**GE Hitachi Nuclear Energy**

MFN 06-308  
Supplement 15

**Subject: Response to Portion of NRC Request for Additional Information  
Letter Number 148 Related to ESBWR Design Certification  
Application -- Classification of Structures, Systems and  
Components (Nuclear Boiler System) -- RAI Number 3.2-19 S03**

**Response to Portion of NRC Request for  
Additional Information Letter Number 148  
Related to ESBWR Design Certification Application  
Classification of Structures, Systems and Components  
(Nuclear Boiler System)  
RAI Number 3.2-19 S03**

Figure 3.2-1. Quality Group and Seismic Category Classification Applicable to Power Conversion System

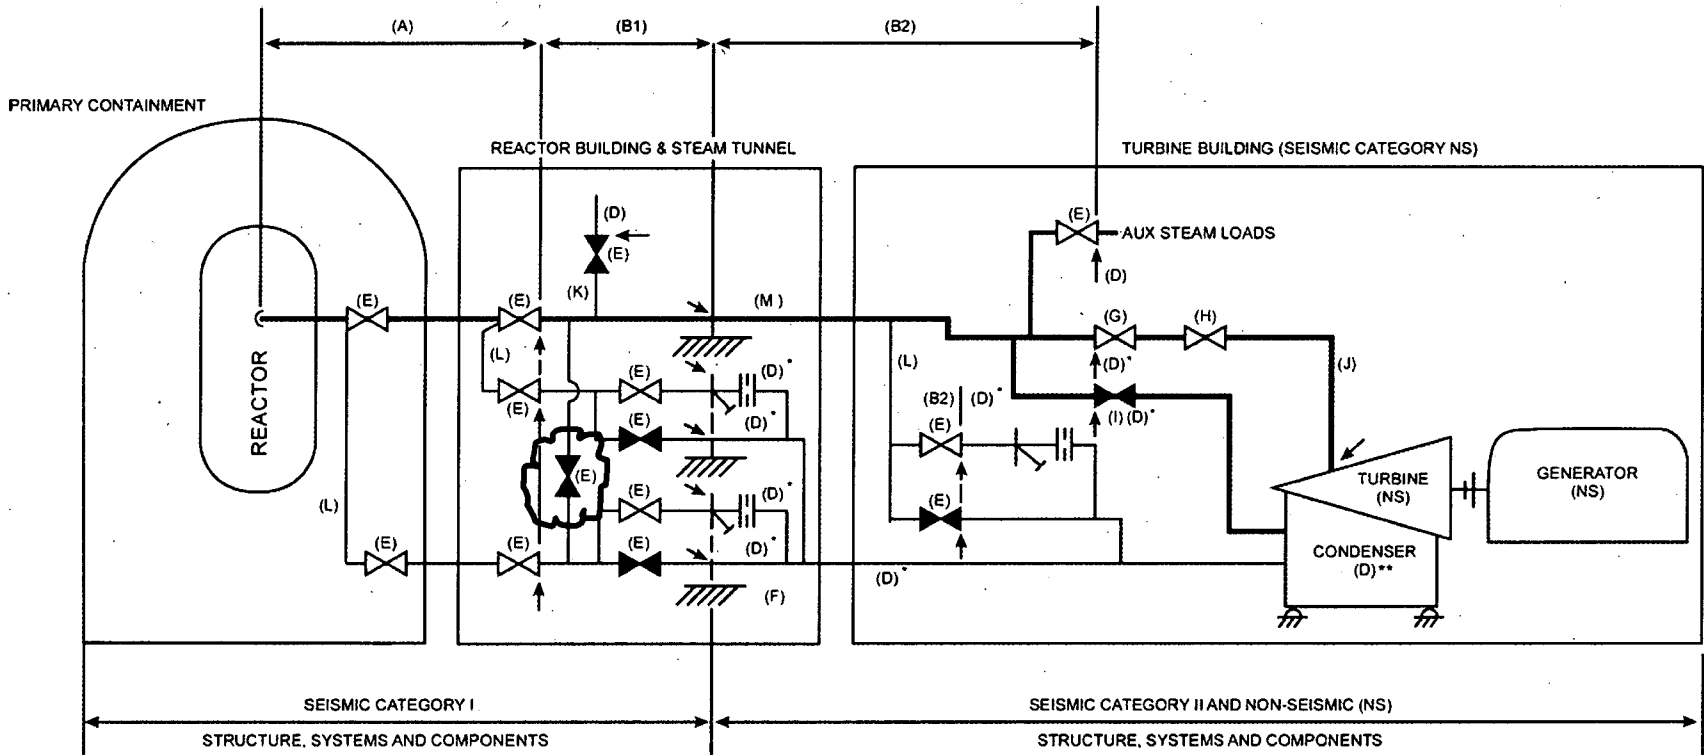
*DCD Tier 2, Revision 4, submitted a revised Figure 3.2-1 to depict the correct valve and piping relationships. Although this figure does not show the second normally closed valve in the main steam (MS) drains stated in the response to RAI 3.2-19 S01, two normally open isolation valves in the MS drains are shown that could be used for isolating a downstream MS drain break. The boundary from safety-related to non-safety related is normally a closed valve, second automatically closed valve or second remotely operated valve. Provided the normally open isolation valves are remotely operated, this classification boundary is acceptable. Please confirm that the isolation valves are remotely operated or otherwise explain the basis for the classification boundary.*

All valves shown on DCD Tier 2 Figure 3.2-1 that are part of Quality Group A have automatic isolation. The isolation signals for these valves are indicated, respectively, in DCD Tier 2 Tables 6.2-16 through 6.2-20. Valves located immediately upstream of steam line drains orifices shown on Figure 3.2-1 in Quality Groups B1 and B2 are normally open and designed to fail open in order to maintain a drainage path in the event of a loss of power to any of the three valves.

There is a line (drawn vertically) on Figure 3.2-1 under Quality Group B1, which directly cross-connects the main steam lines (all four) to the main steam lines drain line with an isolation valve shown as normally open. An open valve in this location would result in an abnormal bypass of main steam to the condenser. GEH has determined that this valve should be represented properly as normally closed, consistent with the design, and will make this correction in the next DCD revision.

DCD Tier 2, Figure 3.2-1 will be revised as noted in the attached markup.
